From: Evaren Page <evaren@gmail.com>
Sent: Monday, August 12, 2024 10:18 PM
To: PL, Subdivision and Zoning
Subject: Objection to PUD 2025

Re: Protest regarding PUD 2025 (C-3 & R-1 base zoning)
13900 N. Bryant Ave – Oklahoma City, OK 73013

PROTEST ITEMS REGARDING REZONING FOR TRACT 1 – “R-4 RESIDENTIAL DISTRICT”

MAP NUMBER
40109C0180H

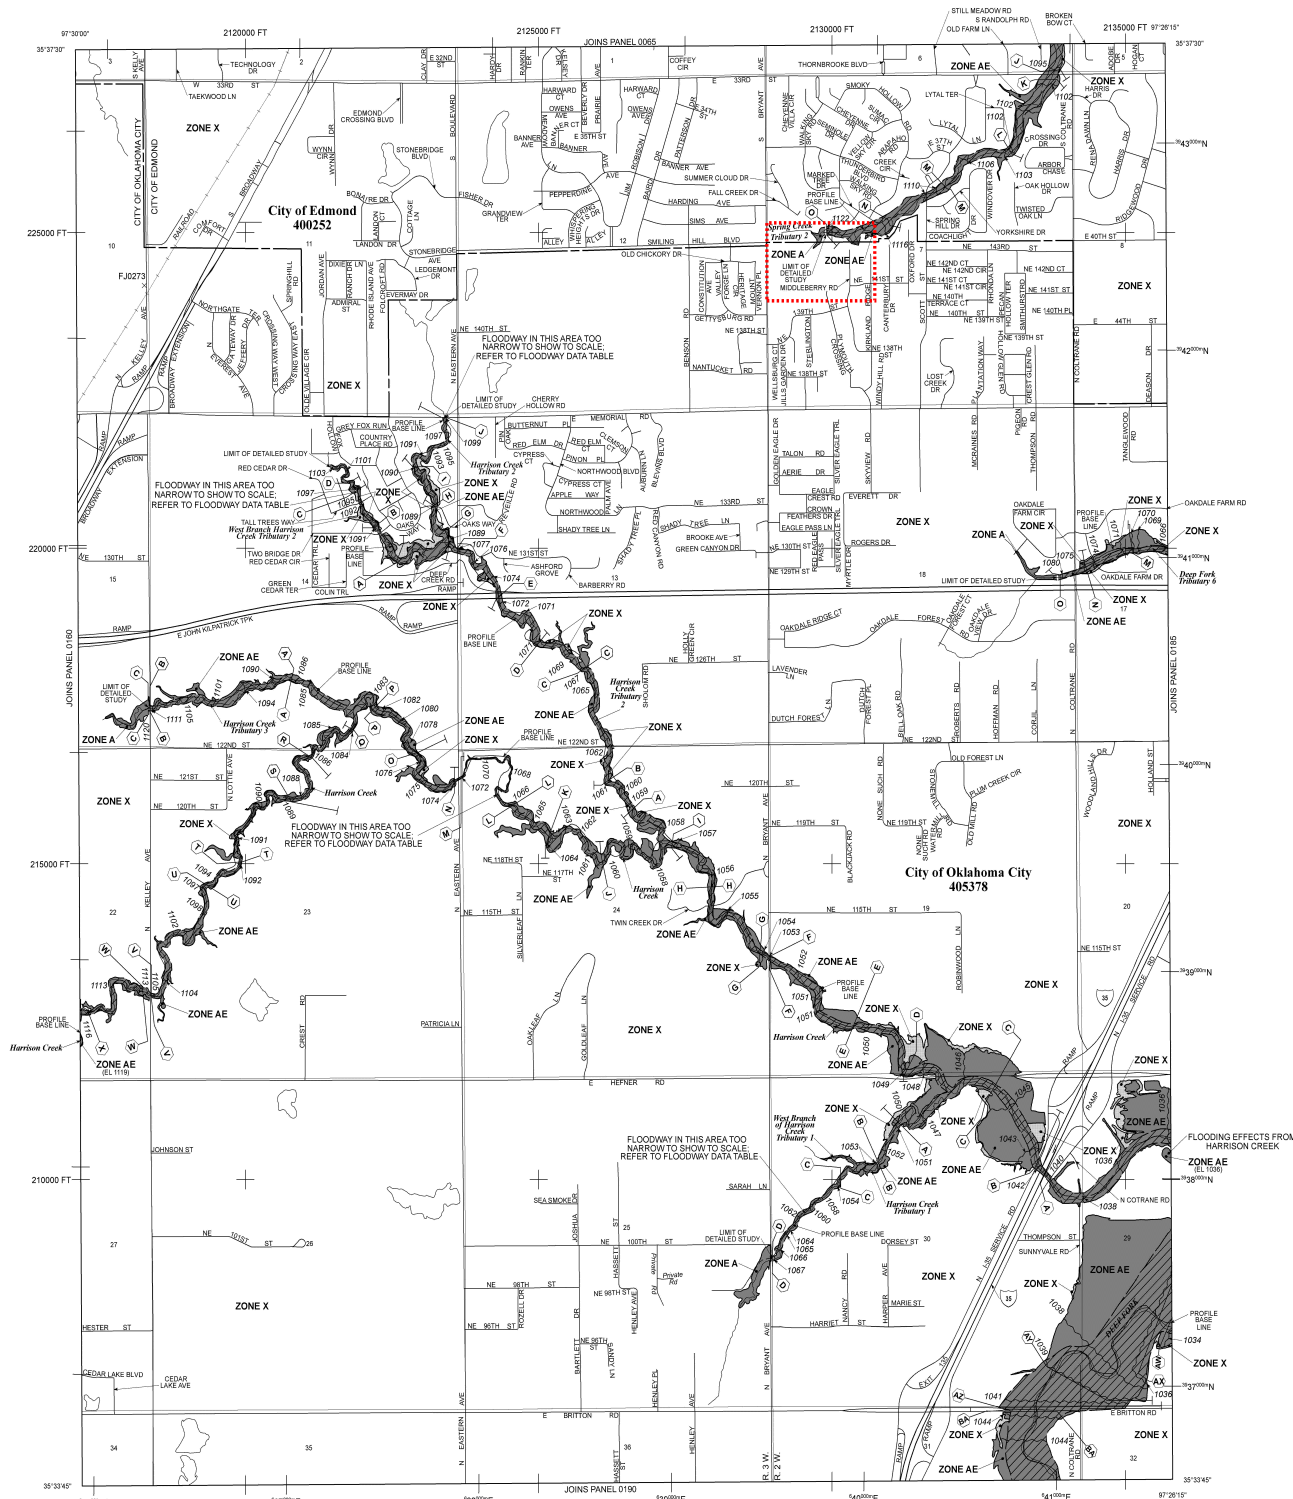
- 5) As required under 59-14150 (B)1(a)-12 for a “Design Statement”: No “stormwater management plan” has been provided for this site. If the Applicant had provided suitable information, it would be apparent that **Tract 1 is literally and figuratively adjacent to a known FEMA flood prone area** located in the “Spring Creek Tributary 2” located just beyond the north property line of Tract 1. (See attached pdf file containing the FEMA flood map 40109C0180H as adopted by OKC...with red highlight for the PUD 2025 area).
